Access Compliance Report Public Rights-of-Way (Curb Ramps)

Main Street: RIVERFORD_RD Cross Street: CHIRPING_SPARROW_WAY Location: S

ADA ID: RPRK220103141214 Ramp Type: Type 4 - Parallel Initial Pass/Fail: Fail Overall Compliance: No Severity Score: 2

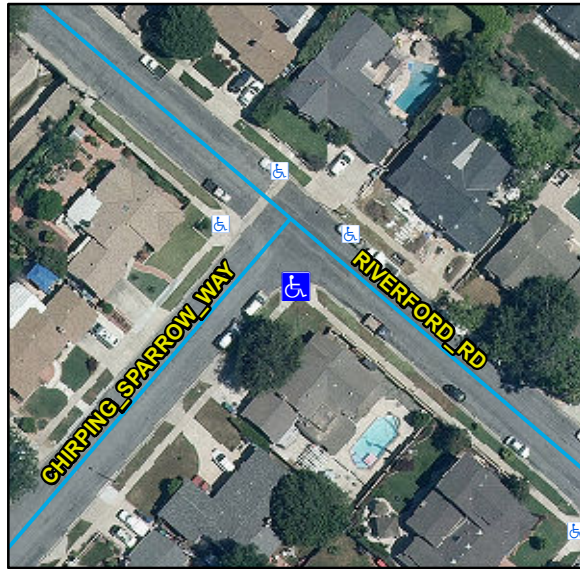
Compliance	Description	Data	Compliance	Description	Data
N/A	Ramp Length LT (in)	165	N/A	Ramp Length RT (in)	144
Yes	Ramp Width LT (in)	72	Yes	Ramp Width RT (in)	88
Yes	Ramp Run Slope LT (%)	8.2	Yes	Ramp Run Slope RT (%)	0.7
No	Ramp Cross Slope LT (%)	2.4	Yes	Ramp Cross Slope RT (%)	1.4
N/A	Landing Present	N/A	N/A	DWS Provided	N/A
N/A	Landing Length (in)	N/A	N/A	DWS Contrast	N/A
N/A	Landing Width (in)	N/A	N/A	DWS Length (in)	N/A
N/A	Landing Run Slope (%)	N/A	N/A	DWS Full Width	N/A
N/A	Landing Cross Slope (%)	N/A		DWS Offset Type	N/A
N/A	Landing Movement Obstructed?	N/A	N/A	DWS Offset Left (in)	N/A
	Landing Movement Type	N/A	N/A	DWS Offset Right (in)	N/A
N/A	Landing Shared	N/A			
N/A	Clear Space	Yes			
N/A	Clear Space To Crosswalk (in)	N/A			
N/A	Marked Crosswalk 1	No	N/A	Marked Crosswalk 2	No
	Crossing 1 Direction	NE		Crossing 2 Direction	NW
N/A	Marked Crosswalk 1 Width (in)	N/A		Marked Crosswalk 2 Width (in)	N/A

Remove & Replace Curb Ramp With Two New Directional Ramps or Equivalent.
